# Technical Service BULLETIN

# MULTI-DISPLAY FUNCTIONS ARE INOPERATIVE

'04 Highlander, Land Cruiser & Prius

### Highlander Multi-Display Connectors:

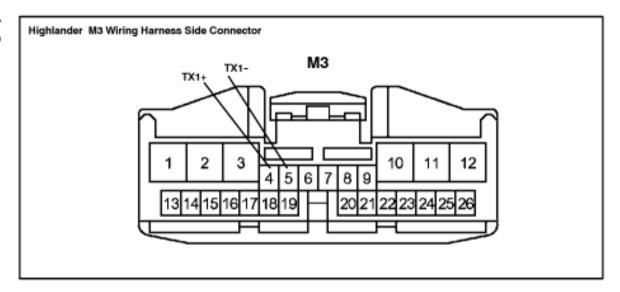
- Check all the TX terminals on the multi-display connectors (please see connector diagrams) and confirm the terminals are fully seated. Replace any damaged terminals or connectors.
- Confirm the connectors to the multi-display are fully seated. Replace any damaged connectors.
- If all the TX terminals are tight and the connectors are fully seated, replace the multi-display.
